DESIGN REVIEW BOARD

DRB20-00606

- Proposed coffee shop with drive-thru

- North of Guadalupe Road on the east side of Signal Butte Road.

3 EAST ELEVATION - REAR
SCALE: 1/4" = 1'-0"

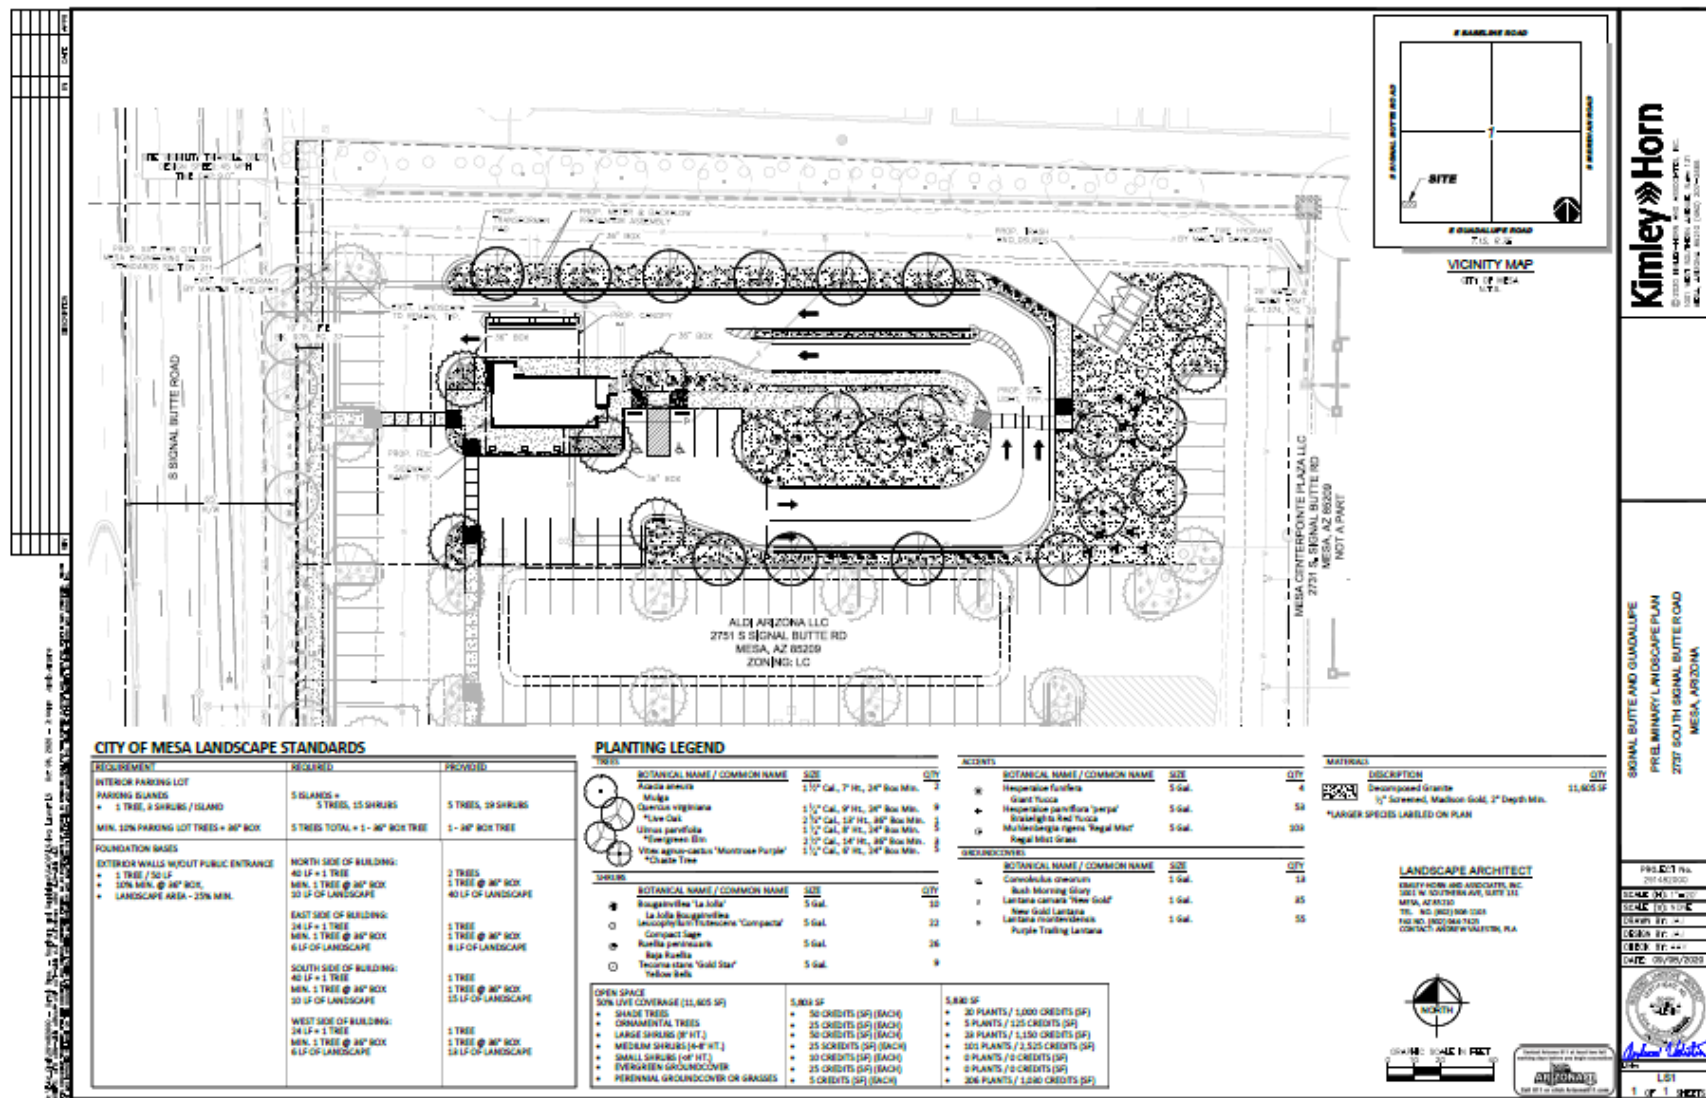
Request: Fiber cement horizontal siding is used for 60% of the eastern elevation.

Requirement: No more than fifty percent (50%) of the total facade may be covered with one (1) single material.
